## Review of Plus-Point with Ceramic Wear-Face

**Figure 1** Tube R2C69 of steam generator 24 scanned in 1997

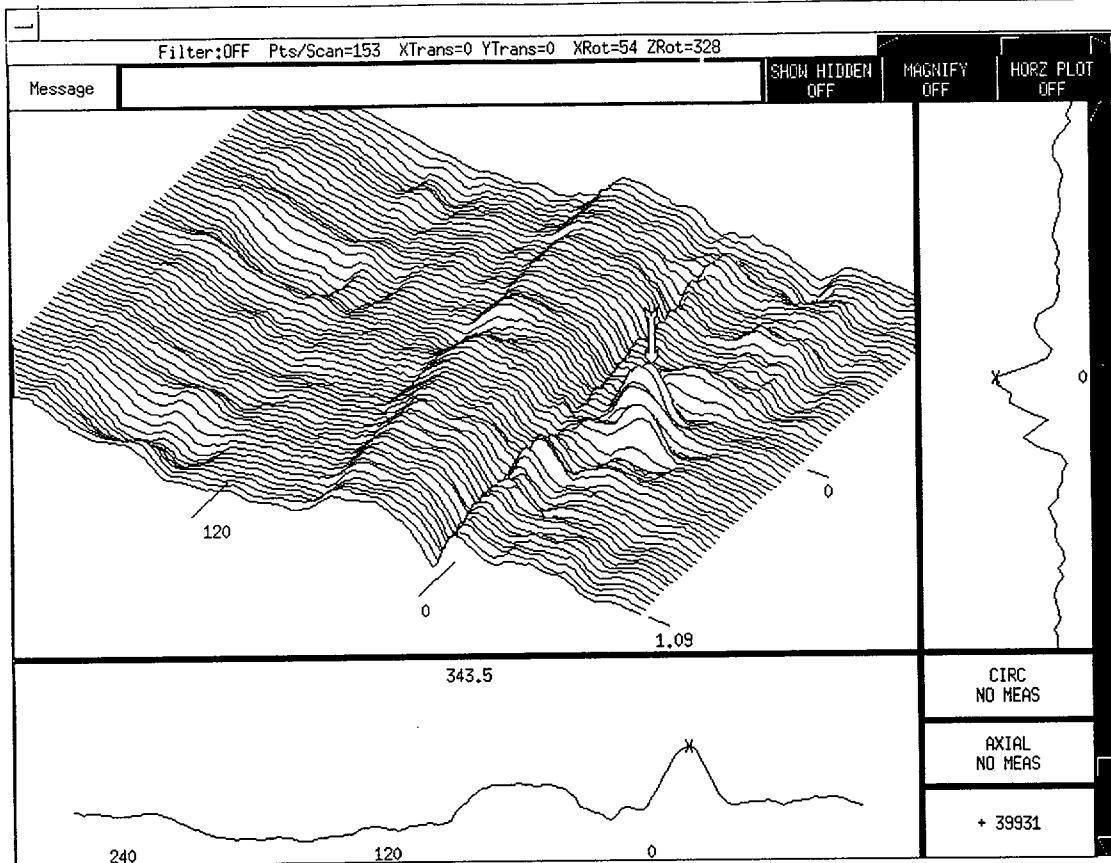
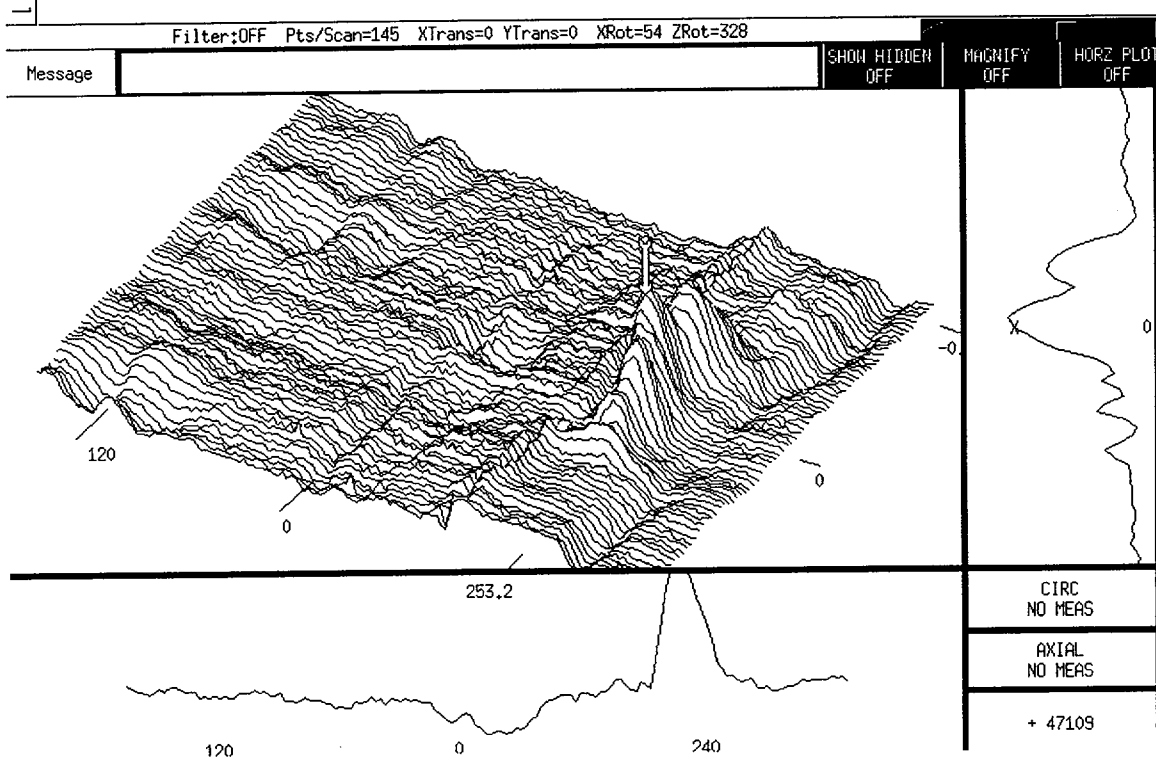
Here are scans of tube R2C69, both made with the mid-range probe at 400 kHz. It clearly appears larger in 2000. You already have scans made in 2000 with the high frequency plus-point, before and after the pressure test. Also, you have profiles of this tube made before and after the pressure test.
